ADDENDUM NUMBER 1

Project: Denman Middle School Window Replacement

This addendum consists of 4 pages including this one, the primary purpose of which is to clarify scope requirements related to the shed relocation on the SW Playground.

ADD.1-SK-0

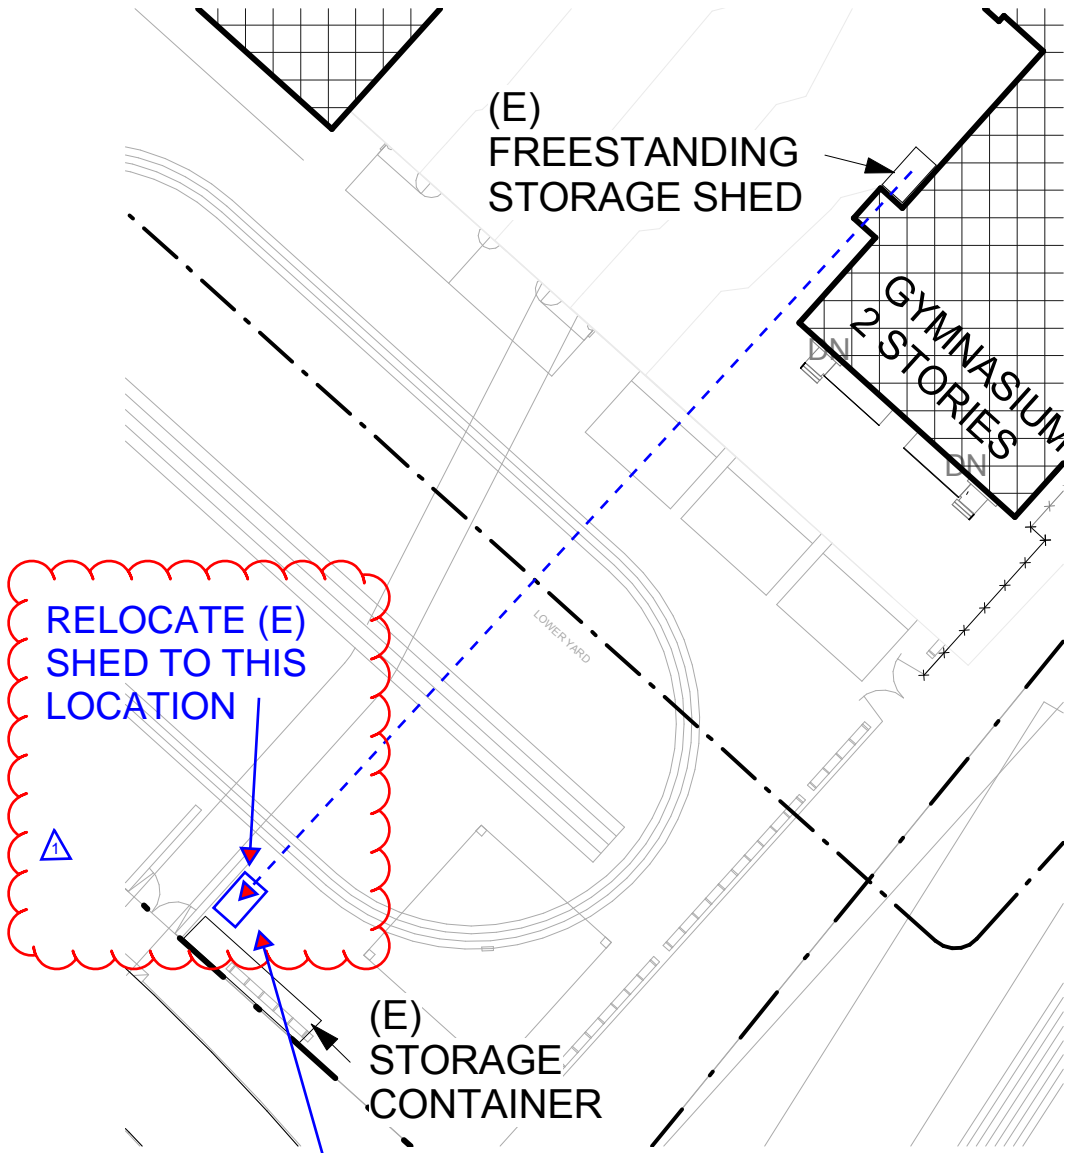
Item No. 1.1 **Add** this clarification for Relocation the (E) shed.
Reference: SK – 0 and A001 which notes “SEE DISTRICT FOR LOCATION”.
Description: SK – 0 provides a precise location for the shed to be moved.

RELOCATE (E)
SHED TO THIS
LOCATION

ADD. 1 - SK-1 EXISTING SHED PLAN

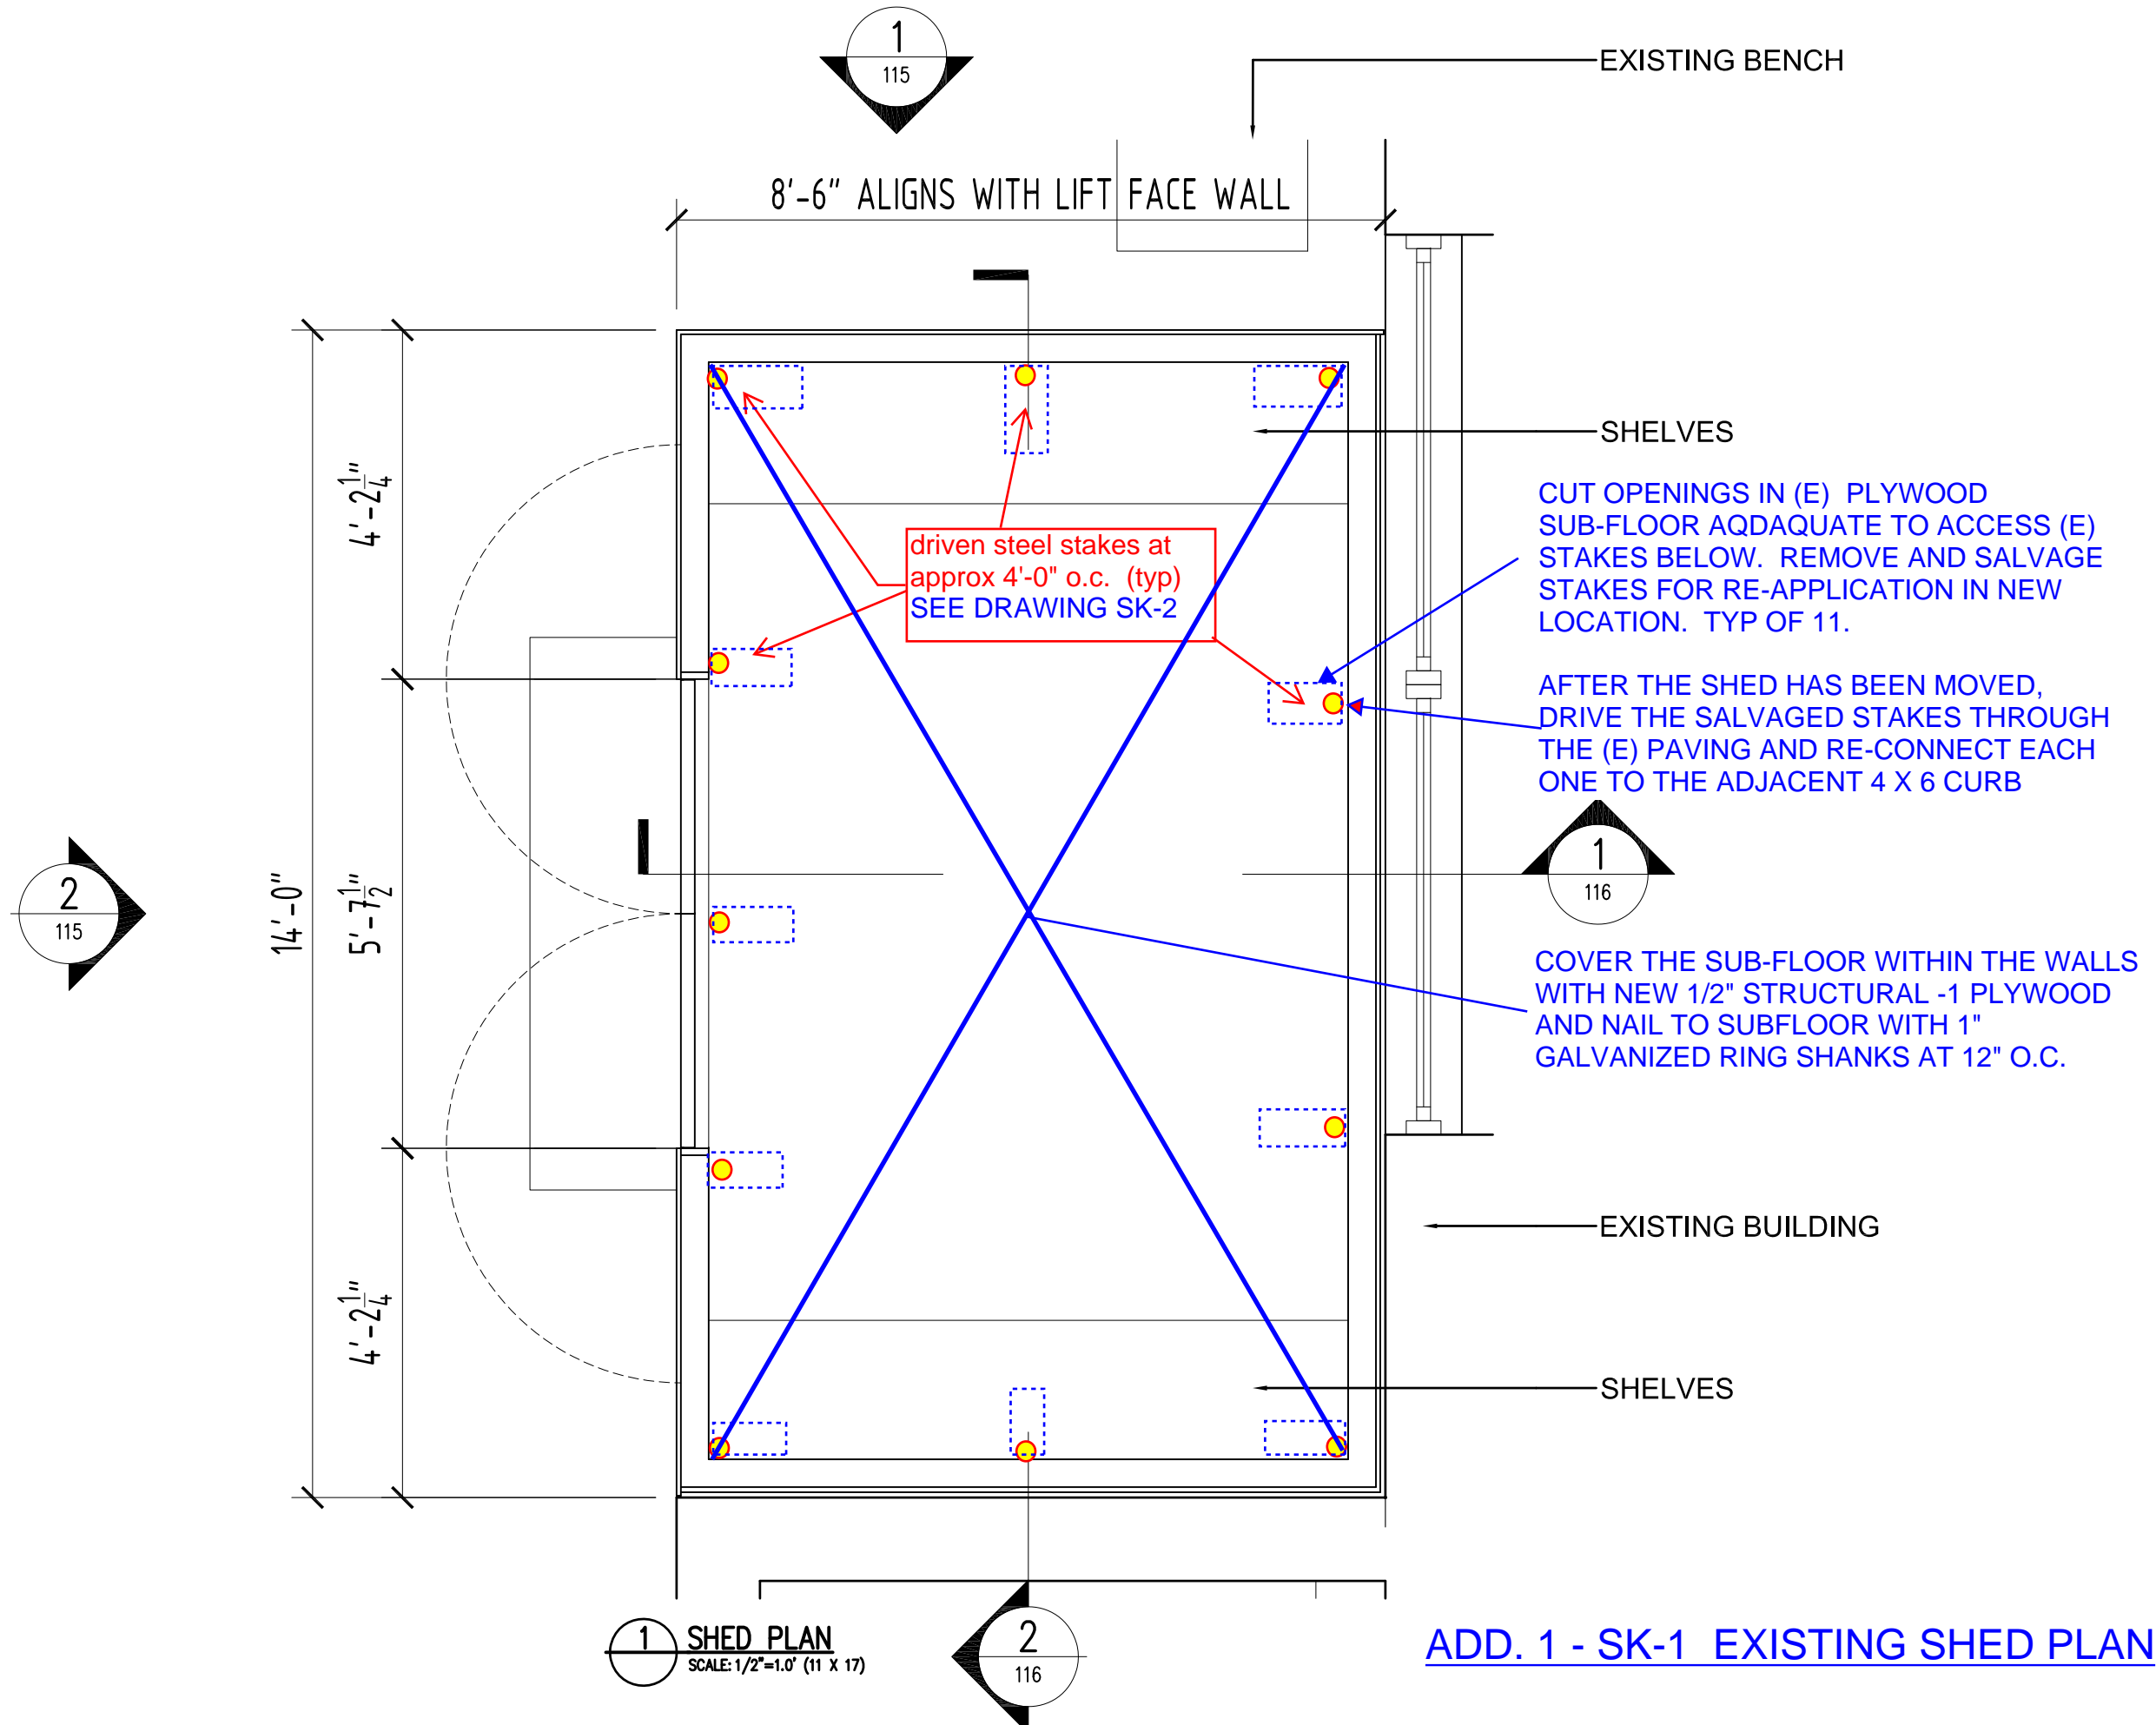
Item No. 1.2 **Add** the following clarification to the scope of work:
Reference: SK – 1 & SK - 2
Description: The (E) shed is anchored and the anchors must be removed in order to relocate it. After placement it must be re-anchored. SK-1 and 2 describe what is required to do that.

RE-ANCHOR THE SHED STRUCTURE
INTO THE PAVEMENT USING THE SAME
METHODOLOGY CURRENTLY USED.

ADD.1-SK-3

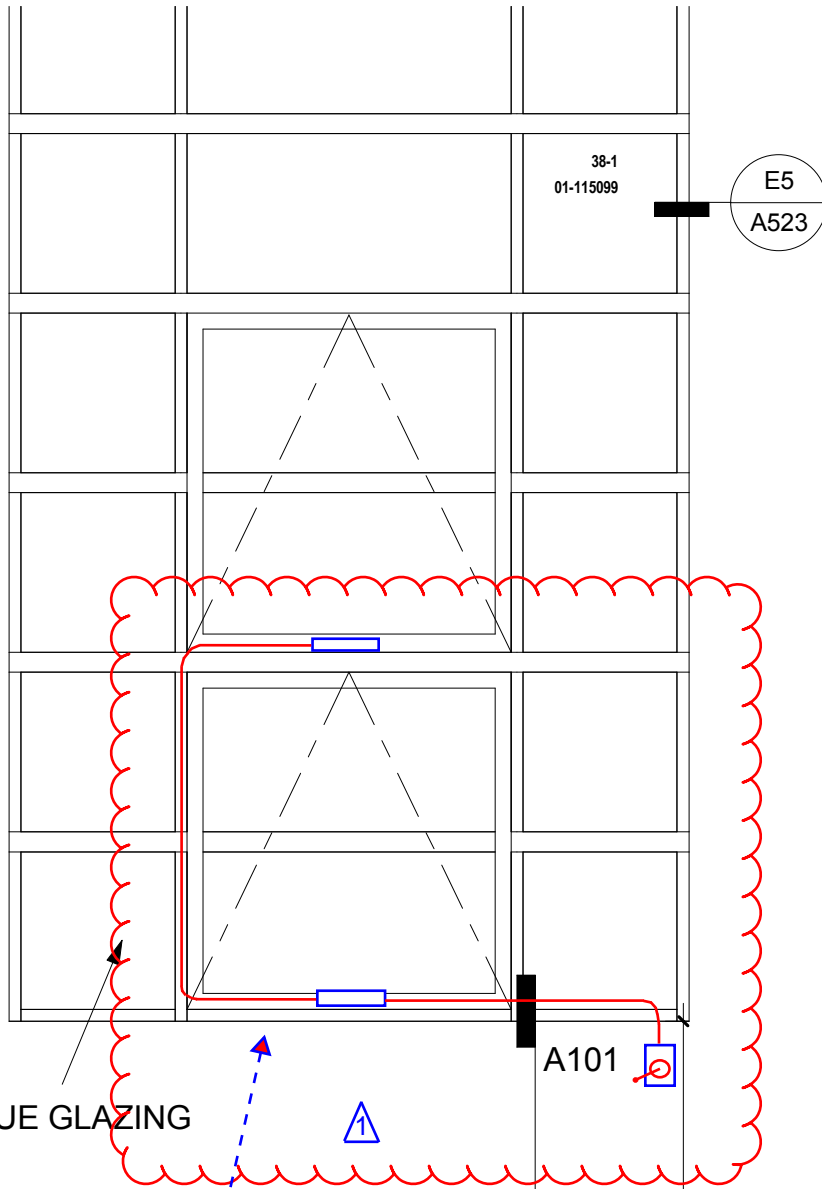
Item No. 1.3 **Add** this clarification for Gymnasium Curtain Wall Vent Operation
Reference: SK – 3
Description: This drawing shows the suggested location for the vent operator by *Clearline Inc.* Although the manual crank is shown on the face of the woodwork below the windows it may be that it needs to be located flat within the sill of the curtain wall to eliminate 1 bend in the cable. Consult with the manufacturer and Architect for most ideal location.

MOUNTING CONFIGURATION FOR CLEARLINE VENT OPERATORS SHOULD BE AS SHOWN HERE
